YOUR Northeastern Log Home BLUEPRINTS

<input type="checkbox"/> Reviewed (No Comment)
<input checked="" type="checkbox"/> Reviewed (See Comment)
<input type="checkbox"/> Reviewed (Resubmit)

Date 10-7-96
BOLE AND WHITTIER, INC.
Architects, Project Managers

NECCO INC. / ALBURG WELCOME CENTER

FLOOR PLAN

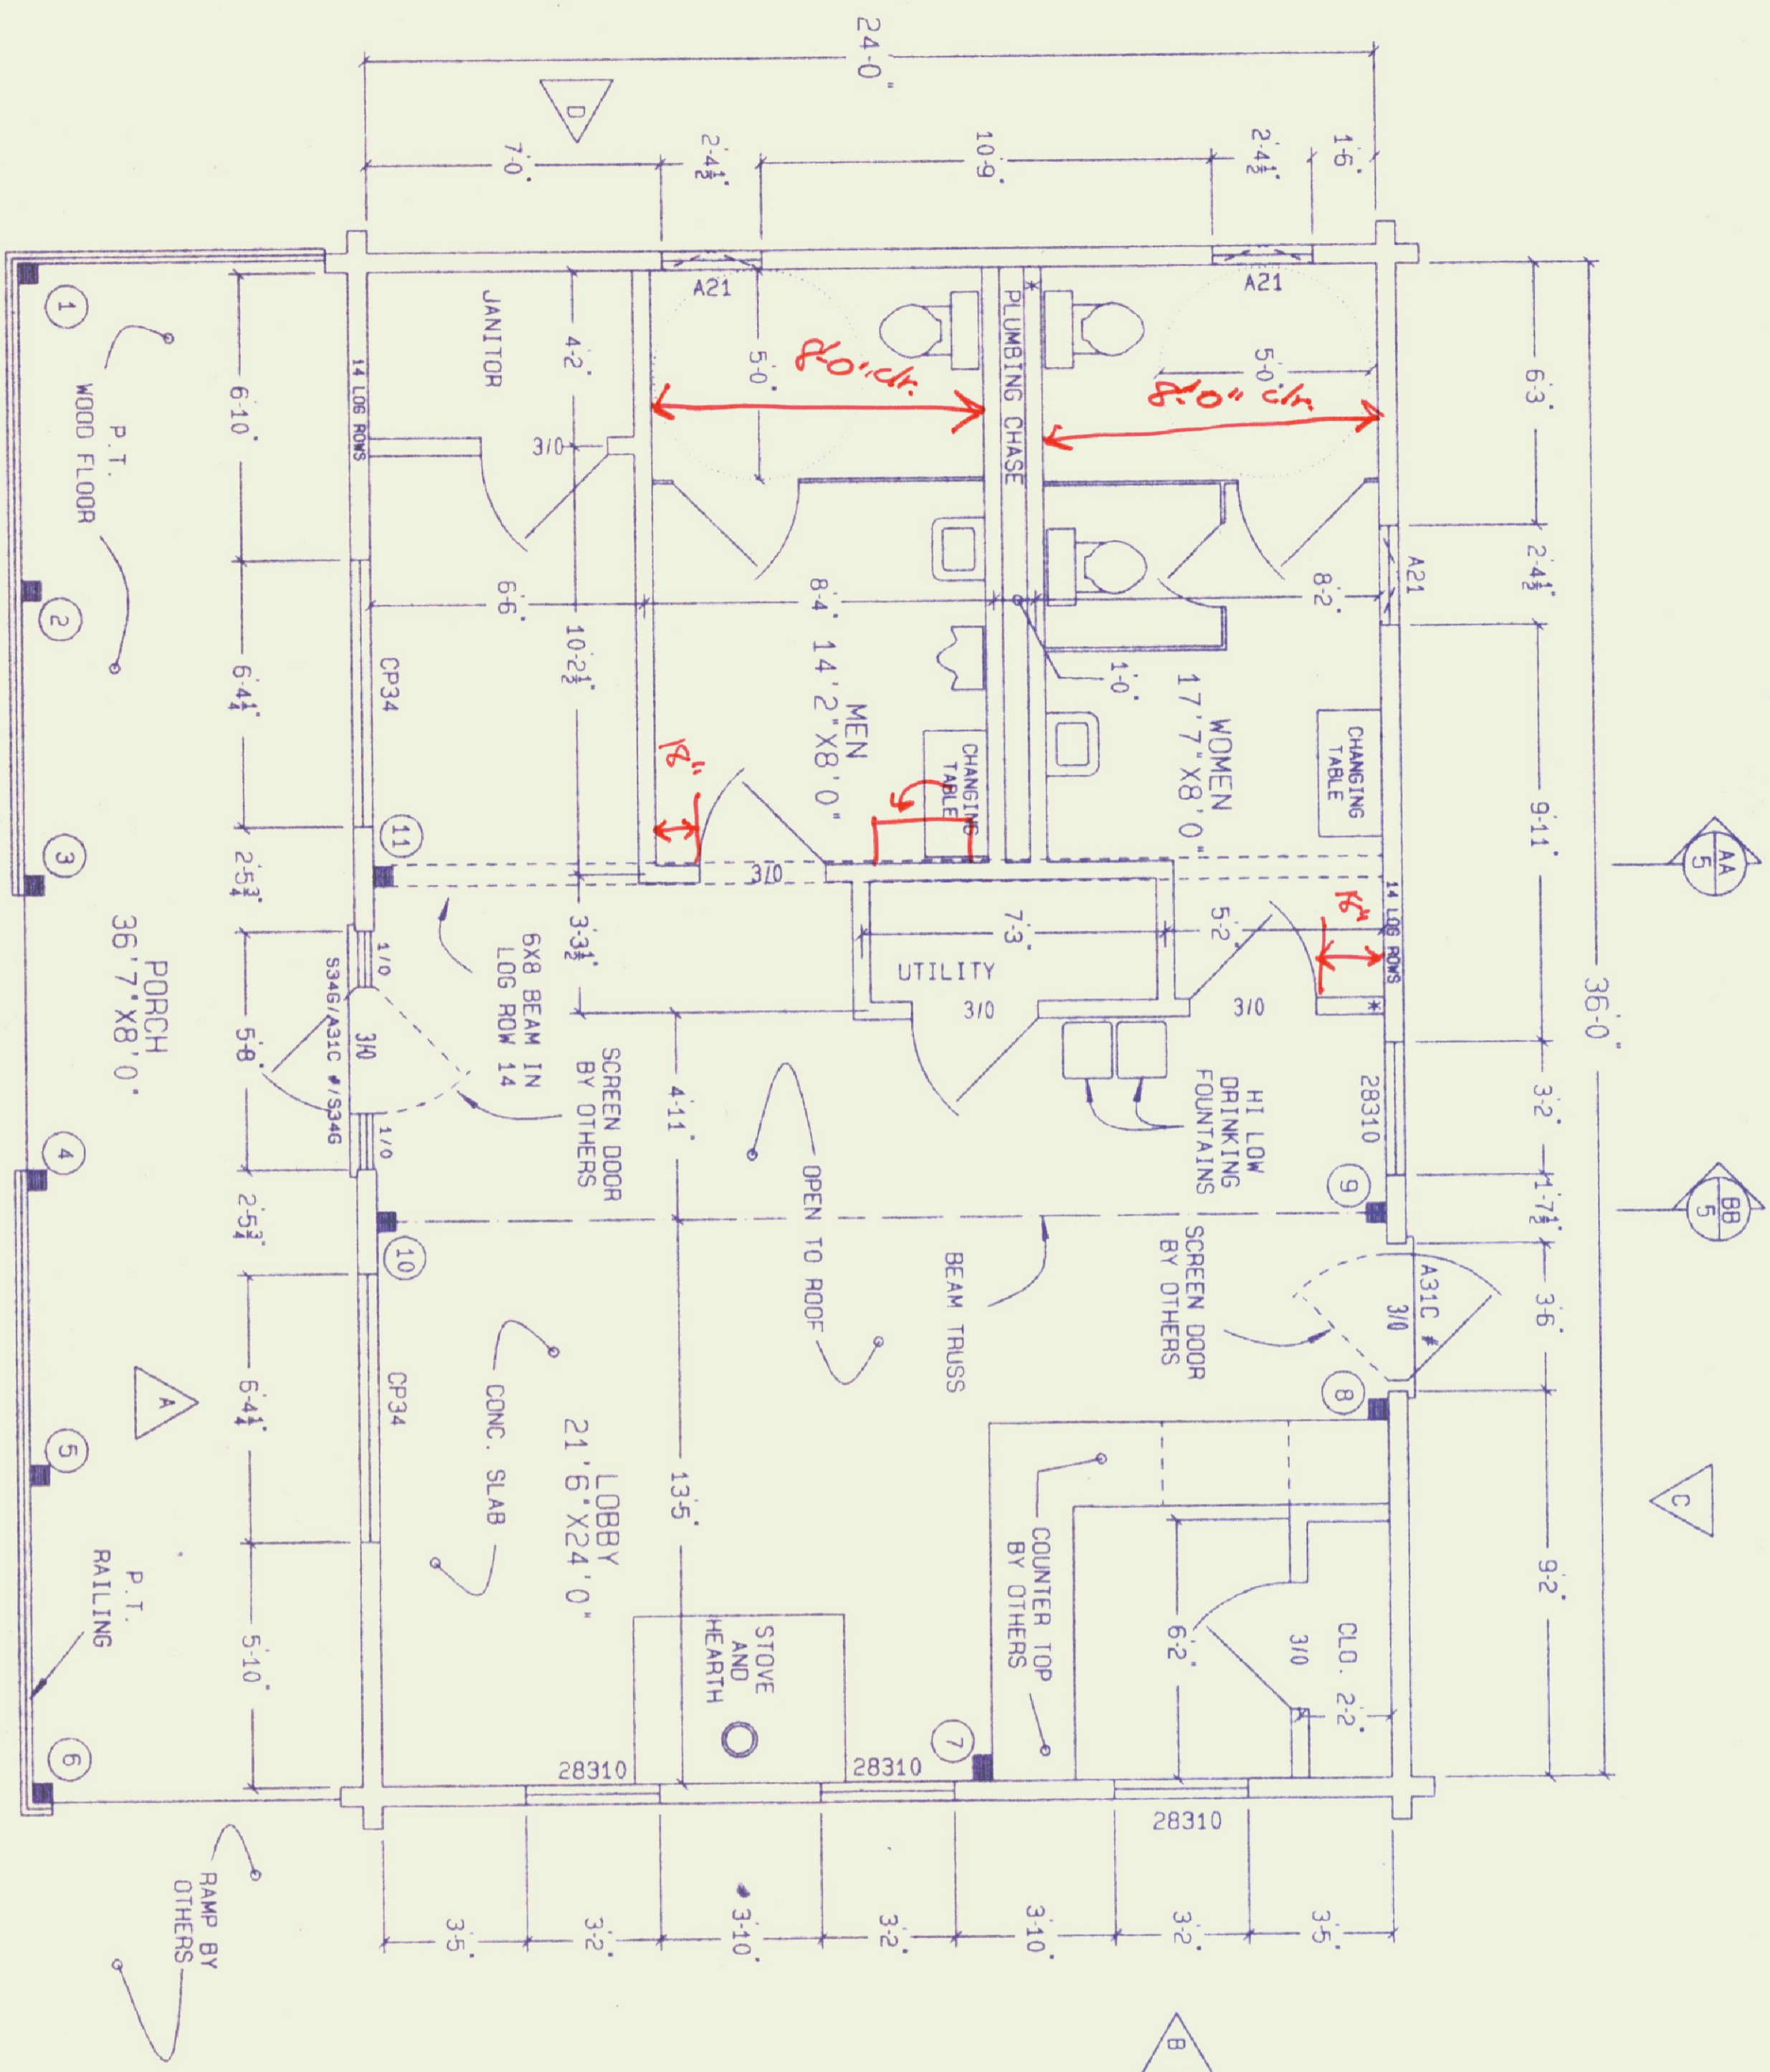
*1. see make ups
2. note reforestation work by draw*
